CONTENTS
APPENDIX 7

7A ANSWERS TO QUESTIONS

FIGURE 7A.5-2
EFFECTS OF POWER SOURCE
CONNECTED AT SPECIFIC POINTS

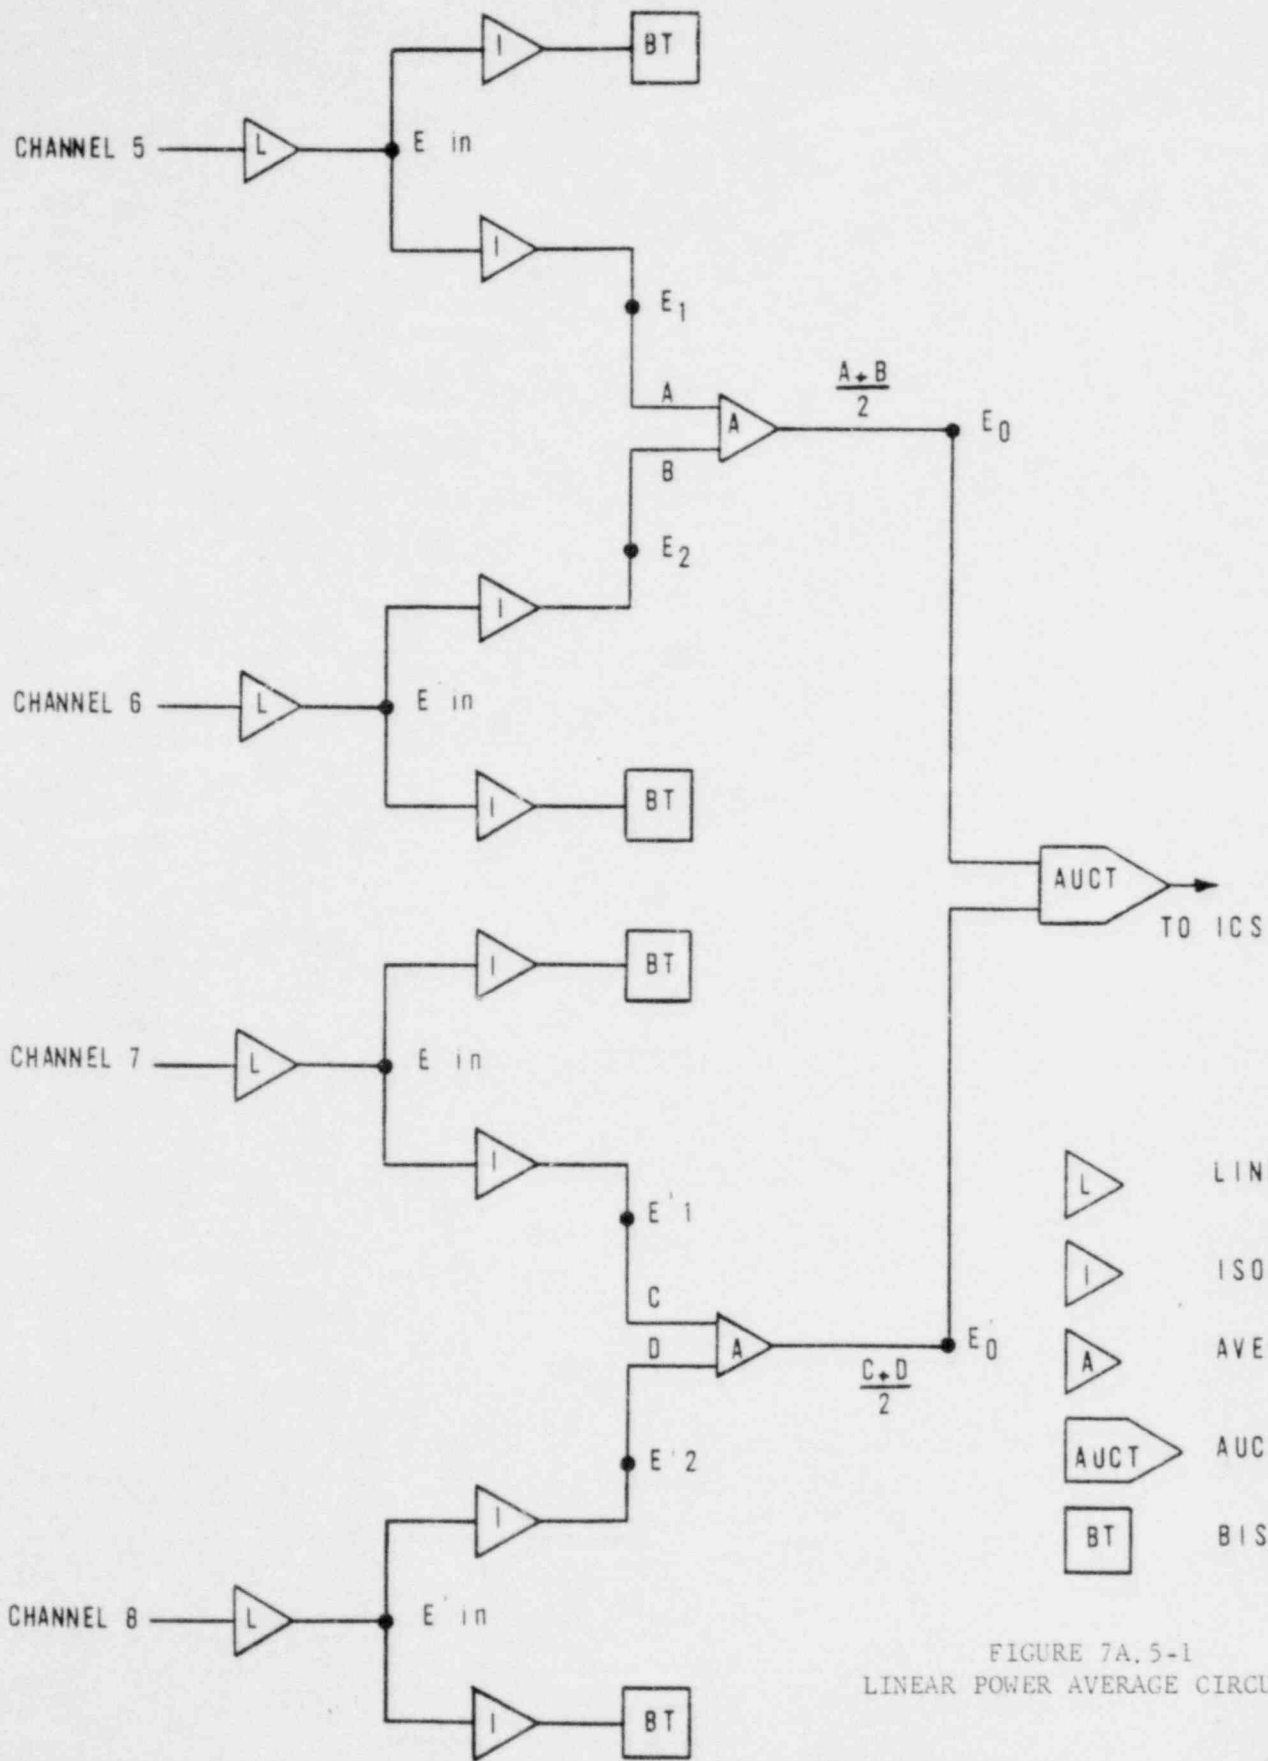
QUESTION 7A.5 (DRL 7.4) Describe and evaluate the changes which will be made in the design of the instrumentation and control systems as a result of the ACRS recommendations contained in the Three Mile letter. Include in the discussion:

- (a) Diversity of engineered safety feature actuation signals and
- (b) Separation of control and protection systems.

The only type of failure with a potential for being reflected into the protection system consists of the direct connection of an electrical power source across one of the reactor power level signals within the averaging system. The effects of such faults have been analyzed and are shown on Figure 7A.5-2 as follows:

1. A power source of 410 volts dc or peak ac may be connected directly across the isolation amplifier output of a power level signal without affecting or failing any portion of the protection system. This has been established by actual test.
2. A power source of 1,300 volts may be connected to any signal point within the system without failing more than one protection system power level input. This has been established by actual test. The test did not go beyond the 1,300-volt value, and does not represent the upper limit which is calculated to be several times this value.

3. The application of a 6,000-volt power source directly across the output of the auctioneer will not affect the operation of the protection system.

4. The application of a 6,000-volt power source directly across the output of any single average amplifier will not affect the operation of the protection system.
5. The application of 10,000 volts across one input of one average amplifier will fail one, but not more than one, protection channel power level signal. The failure of all power level signals to the protection system will occur when the voltage is raised to 12,690 volts with 260-watt capability.
6. The application of 7,000 volts with 140-watt capability to the output of the auctioneer or average amplifier will fail all power level signals.

FIGURE 7A.7-1
 DETAILS OF ISOLATION AS
 EMPLOYED IN POWER RANGE
 CHANNEL OF FIGURE 7.1-2

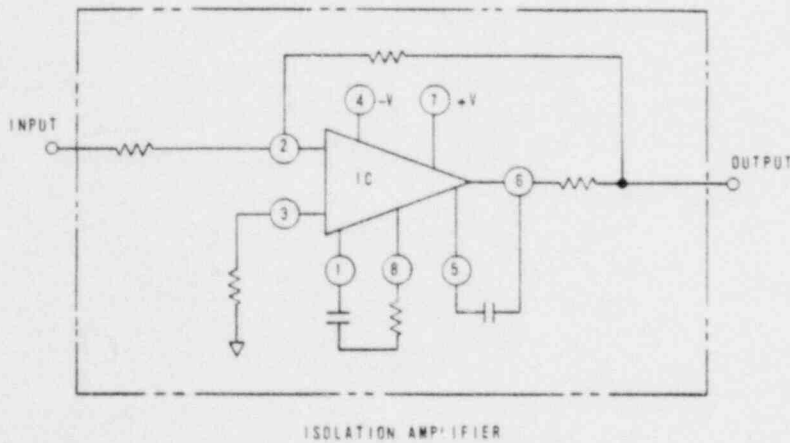
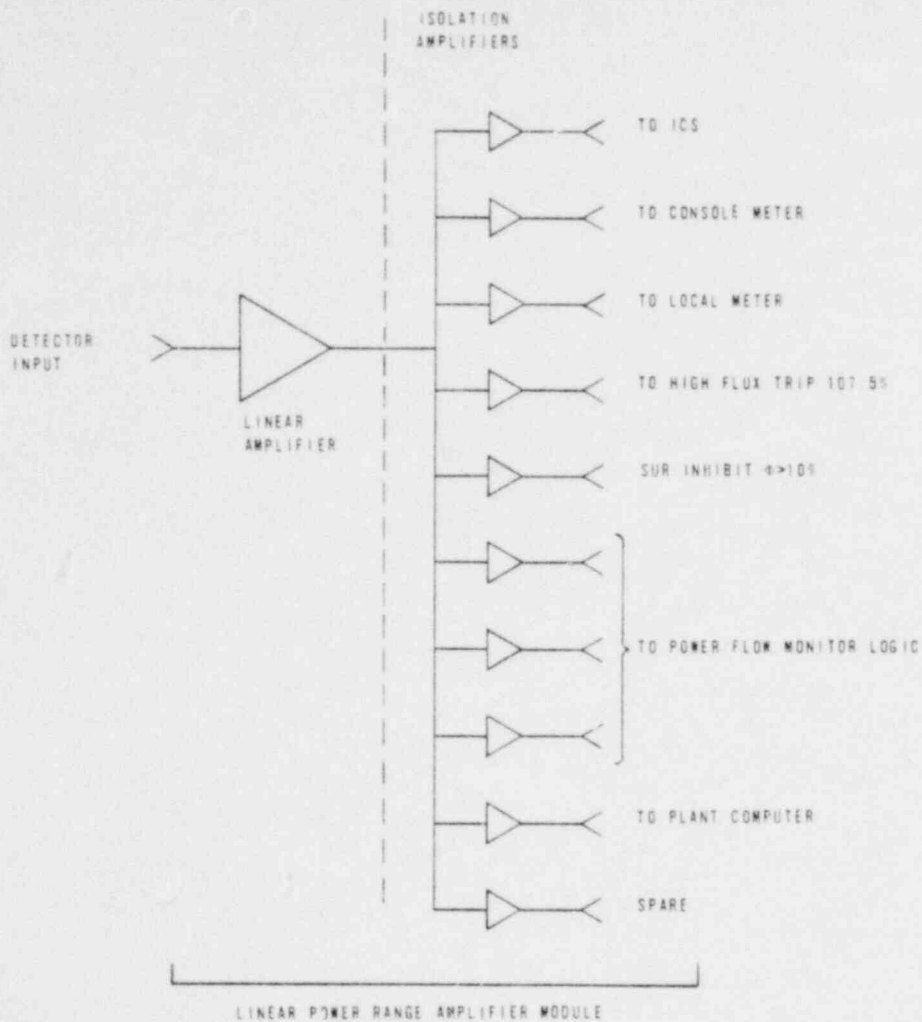
QUESTION 7A.7 (DRL 7.6) With respect to the reactor protection and engineered safety feature signals which feed annunciators and/or a data logging computer, describe and evaluate the design criterion to be used to assure circuit isolation.

Every output therefore from the reactor protection system sensors and the engineered safety features sensors is isolated by a separate isolation amplifier from every other output from the same sensors. As a result each output is insensitive to faults of all kinds on any other output from the same sensor (as described in the answer to Question 7A.5). Accordingly, the signals from protection channel sensors can be sent to annunciators and data loggers or computers without concern for the impact of faults on the protection signal since faults there are totally isolated from the protection channels. e.g. Faults in the annunciator cannot affect the computer, control or protection; faults in the computer cannot affect the annunciator, control or protection, etc.

Figure 7A.7-1 shows the details of an isolation amplifier and the way isolation amplifiers are used in each linear power range module. The arrangement shown is also typical of the reactor coolant pressure and flow inputs to control and protection.
